# Access Compliance Report

## Public Rights-of-Way

Intersection ID: 3217	Main Street: CARVER_POND_RD	Cross Street: SPRING_PARK_DR	Location: N
ADA ID: C594C4EDCA6D	Ramp Type: PerpDiag	Initial Pass/Fail: Fail	Overall Compliance: No
			Severity Score: 36.25

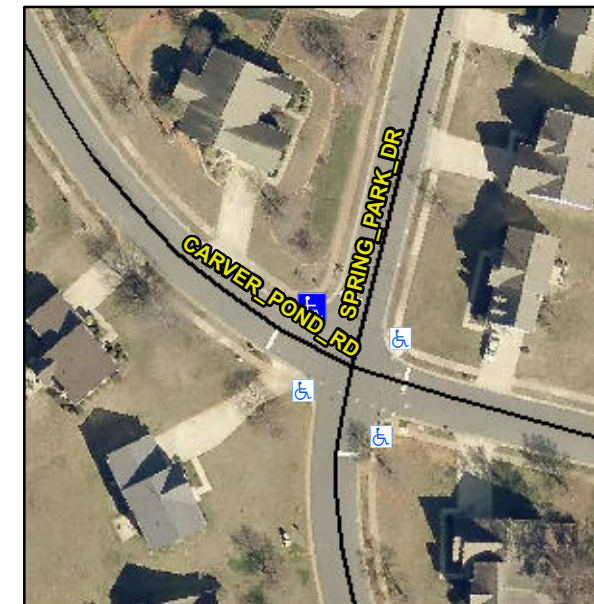
**Not Found, R304.5.1, R304.5.3**

Compliance	Description	Data	Compliance	Description	Data
N/A	Ramp Length (in)	93.0	Yes	Ramp Slope (%)	5.0
No	Ramp Width (in)	31.0	No	Ramp XSlope (%)	4.5
N/A	Flare Type LT	N/A	N/A	Flare Type RT	N/A
N/A	Flare Slope LT (%)	N/A	N/A	Flare Slope RT (%)	N/A
N/A	Flare Traversable LT?	N/A	N/A	Flare Traversable RT?	N/A
N/A	Landing Length (in)	N/A	N/A	DWS Provided?	N/A
N/A	Landing Width (in)	N/A	N/A	DWS Contrast?	N/A
N/A	Landing Slope (%)	N/A	N/A	DWS Length (in)	N/A
N/A	Landing X Slope (%)	N/A	N/A	DWS Full Width?	N/A
N/A	Landing Curb? (Y/N)	N/A	N/A	DWS Offset (in)	N/A
N/A	Shared Landing?	N/A			
N/A	Gutter Ponding?	N/A	N/A	Gutter Slope (%)	N/A
N/A	Gutter Lip Ht (in)	N/A	N/A	Gutter X Slope (%)	N/A
N/A	Painted X Walk1?	No	N/A	Painted X Walk2?	No
	X Walk 1 Direction	To SW		X Walk 2 Direction	To SE
N/A	X Walk 1 Width (in)	N/A	N/A	X Walk 2 Width (in)	N/A
	X Walk 1 Slope (%)	0.8		X Walk 2 Slope (%)	2.7
	X Walk 1 X Slope (%)	4.9		X Walk 2 X Slope (%)	3.5

**Remove & Replace Curb Ramp With Two New Directional Ramps or Equivalent.**
